## ENGINE DISTRIBUTORS SERVICE BULLETIN

### GX120 • GX160 • GX200 FUEL FILLER CAP DOES NOT VENT PROPERLY

FUEL FILLER CAP

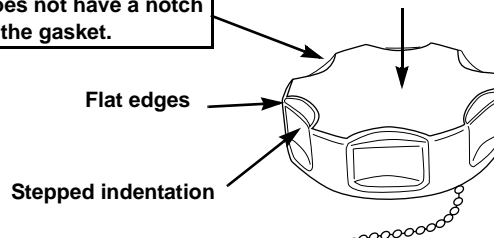
Replace the fuel filler cap with either one of the new style vented caps shown.

- The countermeasure cap can be recognized from the original cap by a notch in the gasket.
- The new production cap can be identified by flat edges, stepped indentations, and a top that is curved inward.

The countermeasure cap and new production cap are interchangeable with each other.

COUNTERMEASURE CAP  
PN 17620-Z4H-010

Has a notch in the gasket.

NEW PRODUCTION CAP  
PN 17620-Z4H-020

Does not have a notch in the gasket.

**COUNTERMEASURE CAP SHOWN**

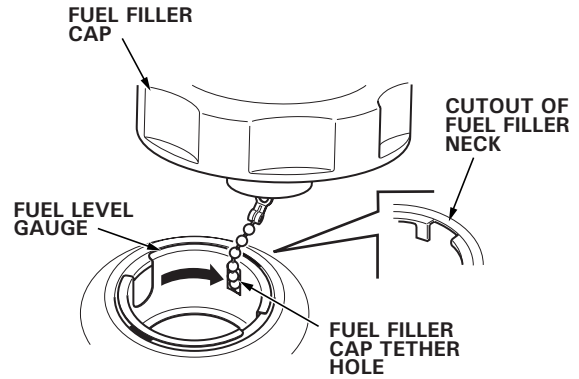
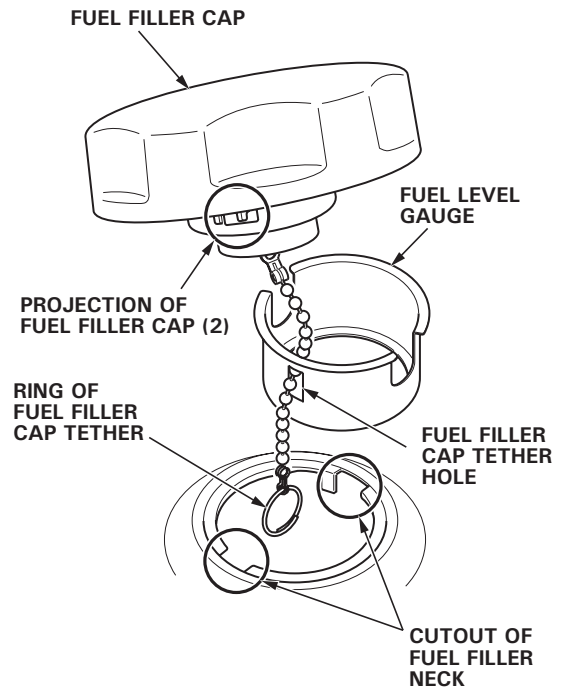
1. Remove the fuel filler cap from the fuel filler neck.
2. Turn the fuel level gauge to align the fuel filler cap tether hole with the cutout of the fuel filler neck.
3. Remove the fuel level gauge from the fuel filler neck.

1. Lower the ring of the fuel filler cap tether into the fuel filler neck.
2. Install the fuel level gauge into the fuel filler neck by aligning the fuel filler cap tether hole with the cutout of the fuel filler neck, and then turn the fuel level gauge 90° in the reverse order of removal.

3. Install the fuel filler cap on the fuel filler neck by aligning the projections of the cap with the cutouts of the fuel filler neck, and turn the fuel filler cap clockwise 180° to lock it.
